# CITY OF ALBUQUERQUE

RE: **Lot 9 Block 2 SAD 227 Unit 28**  
**6708 Rimrock NW**  
**Grading and Drainage Plan**  
**Engineers Stamp Date 8/13/2020 (D10D019)**

## DRAINAGE AND TRANSPORTATION INFORMATION SHEET (REV 6/2018)

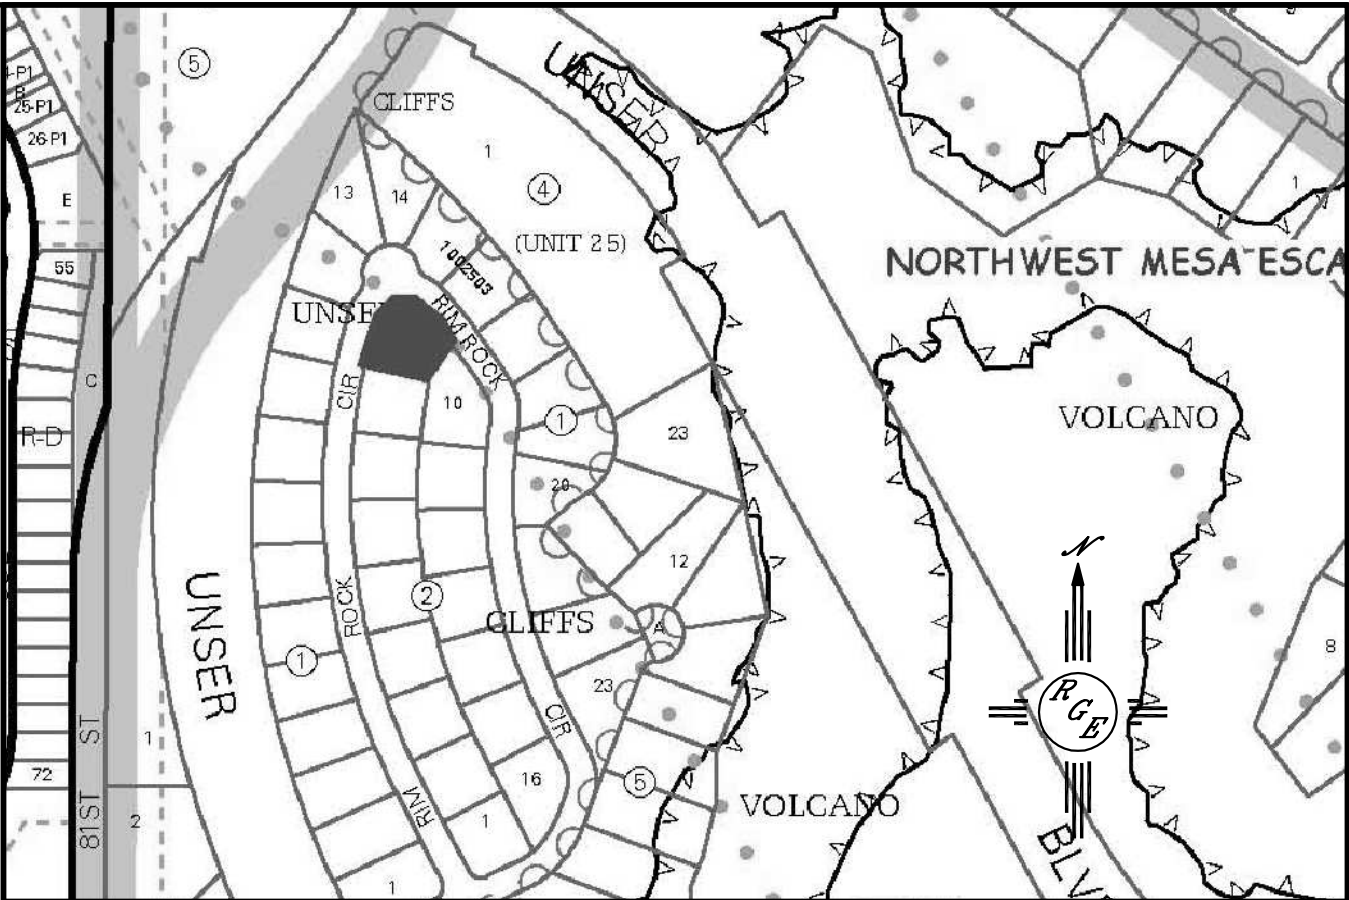
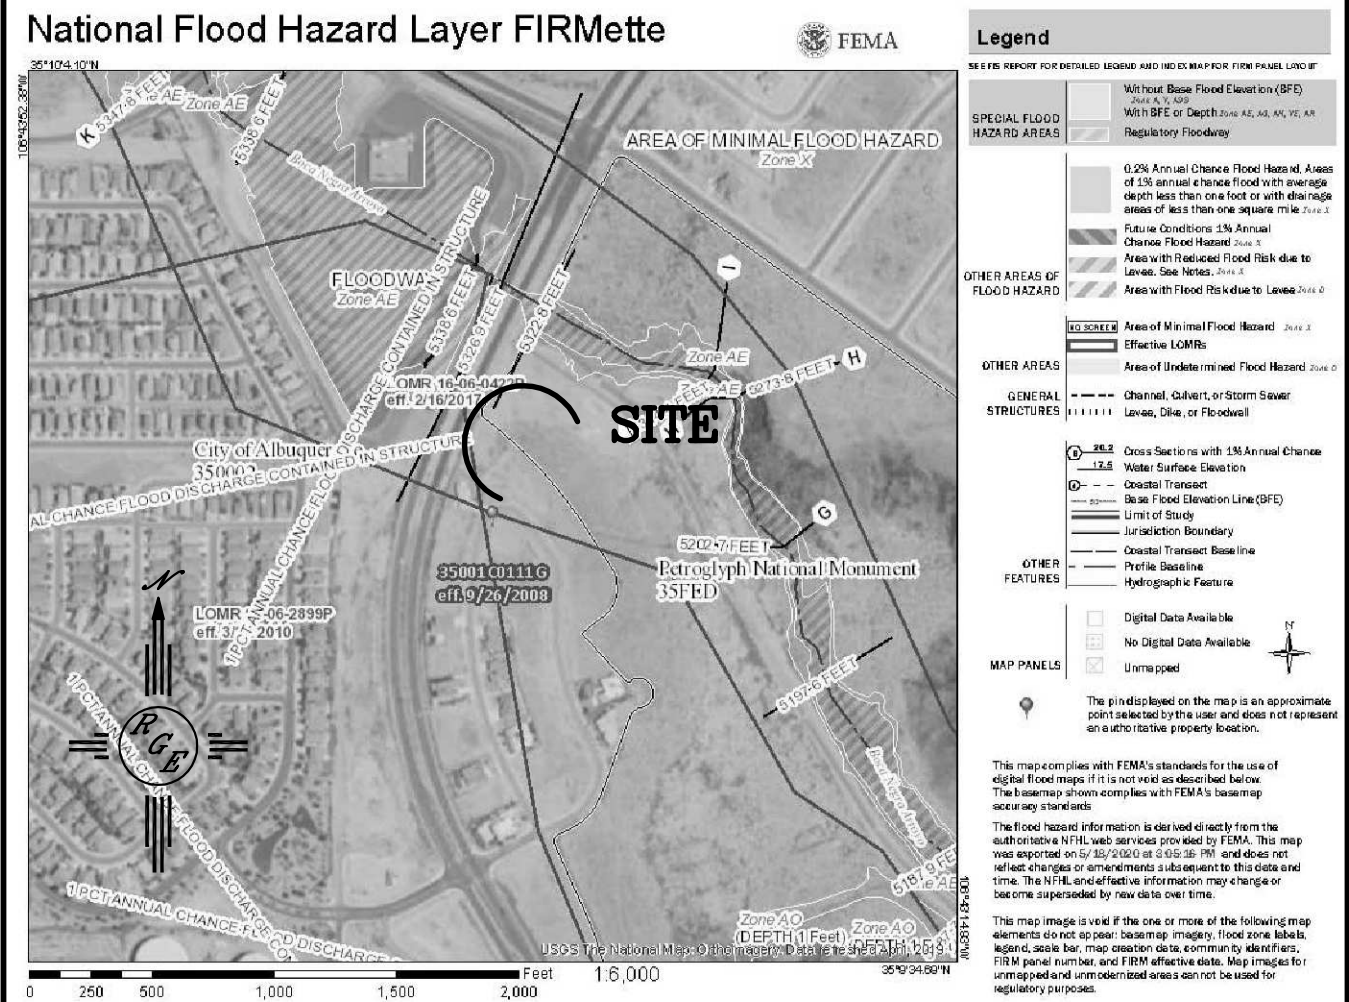
**Reiterate to the Owner/Contractor that a separate permit for any garden/retaining wall must be obtained, with the approved G&D plan.**

Prior to Building Permit approval, a **Pad Certification** will be required. Inform the contractor/owner not to pile dirt in the street as a ramp to climb the curb. If dirt is found in the street the pad cert. will be denied.

Prior to **Certificate of Occupancy release**, Engineer Certification per the DPM checklist of this plan will be required.
